Cortina Systems® LXT971A, LXT972A, LXT972M Single-Port 10/100 Mbps PHY Transceivers

Specification Update

15 March 2007

Revision 13.0

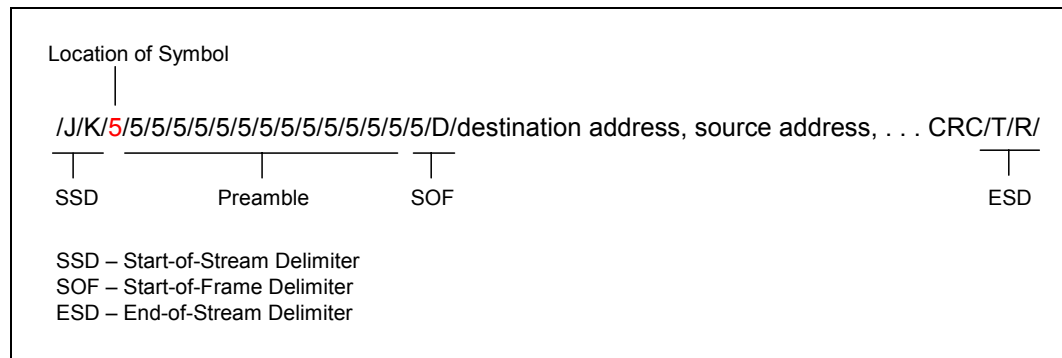
Problem An illegal symbol placed immediately after the SSD (preamble after JK) is not detected. However, any subsequent corrupt symbol will be detected.

Implication RXER does not assert if this symbol location is corrupted. However, an error in this location does not affect packet integrity.

Workaround Use the MAC layer protocol to detect corrupt symbols in the packet.

Figure 10 Ordering Information Matrix - Sample

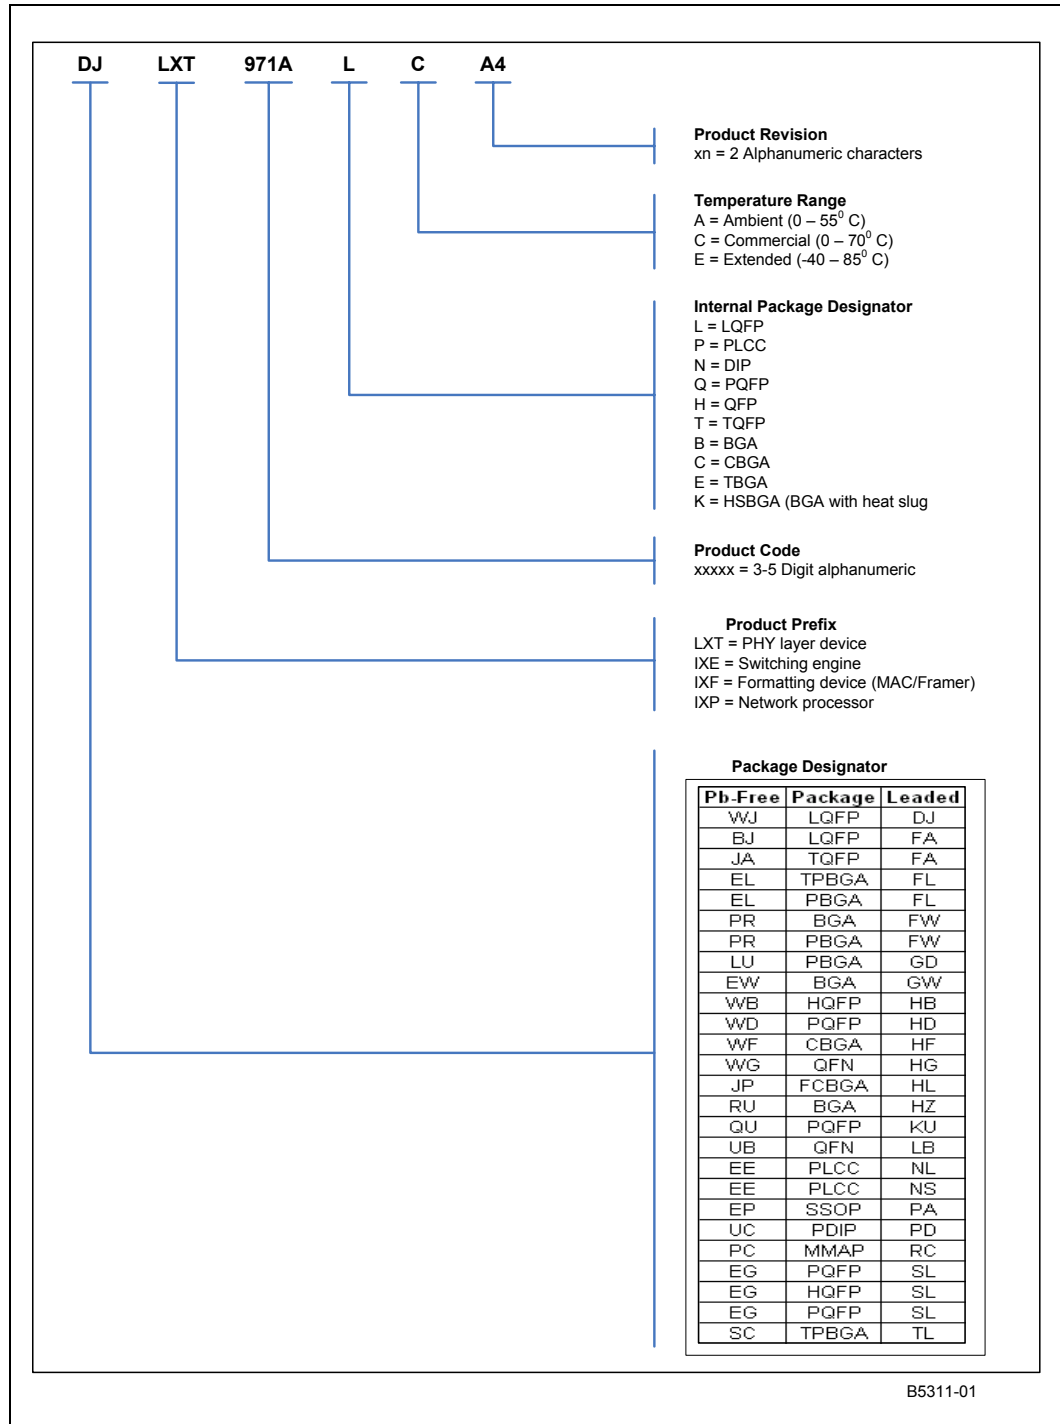
Change 2. The ordering information matrix changes as shown in [Figure 10](#).
